Reply to Office Action
Appl. No. 668,586
Page 2

REMARKS

Fig.2

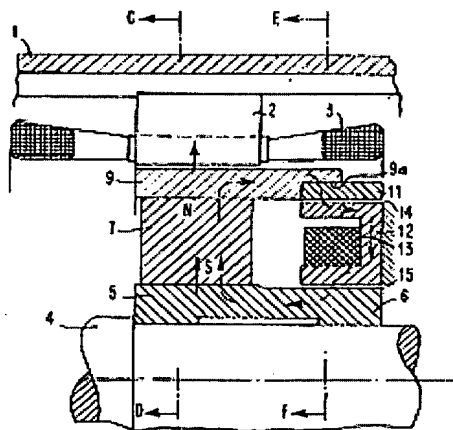
Fig. 2 shows the shunt path passing through PM element 7 as described at col. 3, lines 16-43.

Rosenberg, U.S. Pat. No. 3,411,027

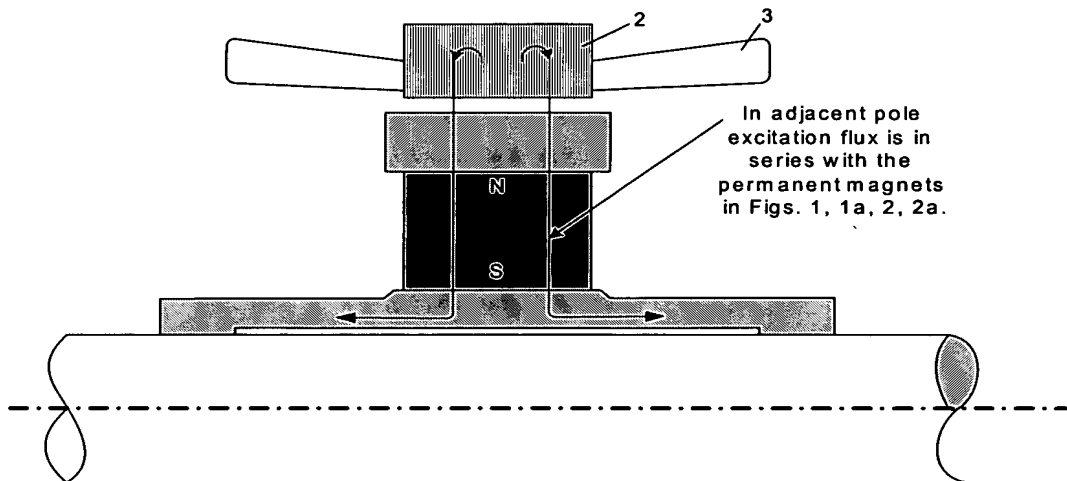
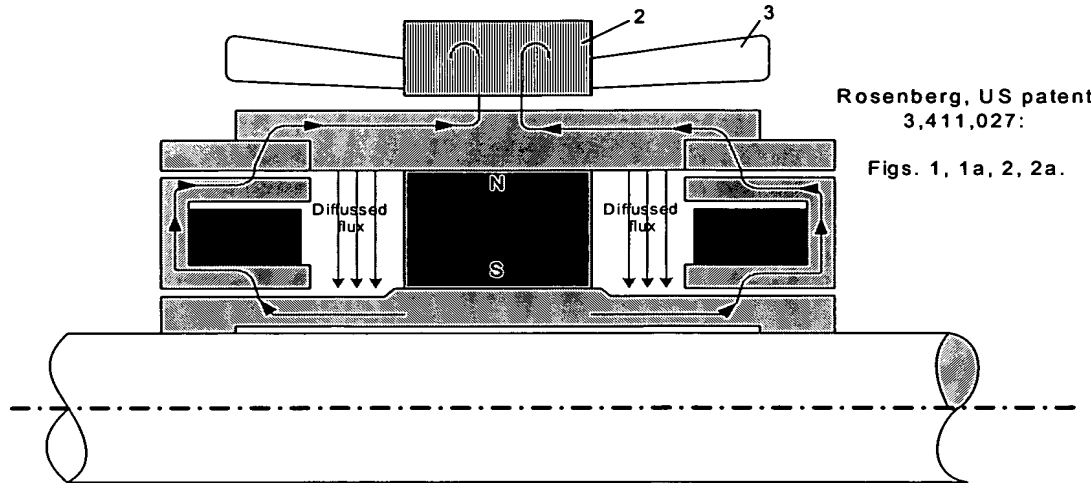
Referring to Rosenberg's figures 1, 1a, 2, and 2a, the stationary control coil structure is in a magnetic shunt relation (or in parallel) with the permanent magnet. Consequently, the control coil produces an excitation flux that goes into the stator. The Rosenberg motors taught in US Patent 3,411,027 date back to 1968, but in the passage of nearly 40 years, the Rosenberg motors have not been commercially successful.

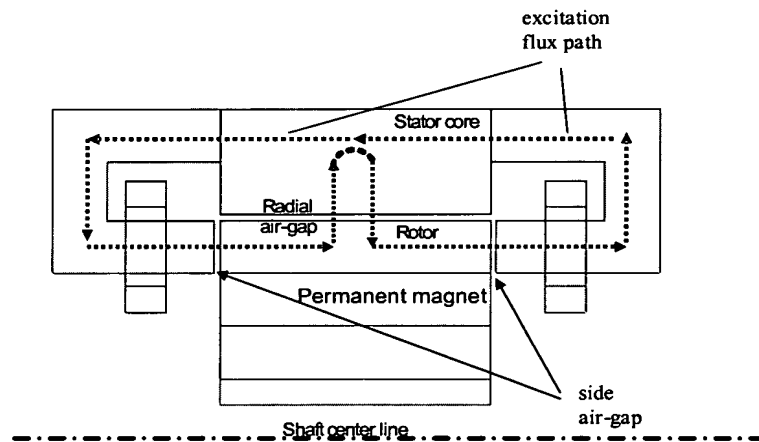
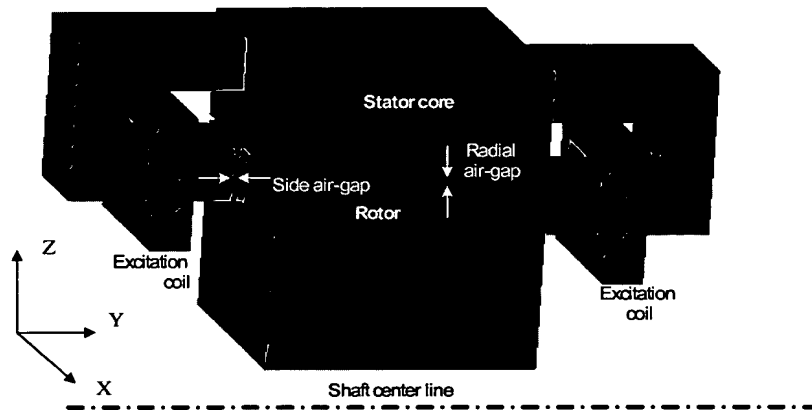
The first figure above shows flux leakage paths provided in Rosenberg. In the second figure, it is shown how Rosenberg is producing flux to flow through the PM material as part of its magnetic path to the main air gap.

Schematics of the Present Invention

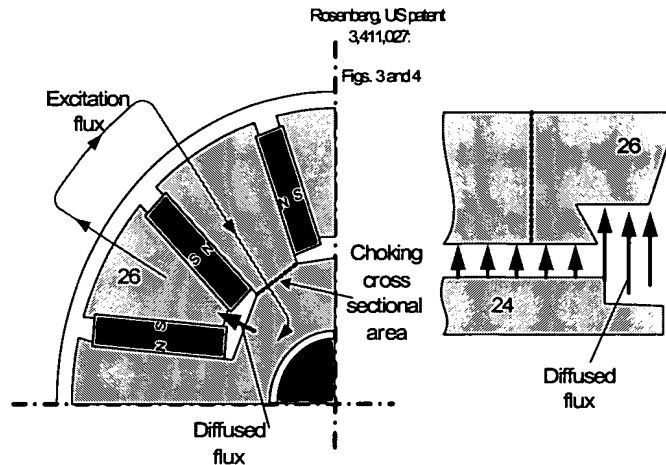
In the machine of the present invention shown below, the diffusion of the excitation flux is contained by the permanent magnets and the excitation flux is not in series with the permanent magnet as conceptually shown in the following figure. Consequently, the flux enhancement is significantly stronger than that of the Rosenberg machine. The present invention is teaching a *high strength* and *undiffused* technology.
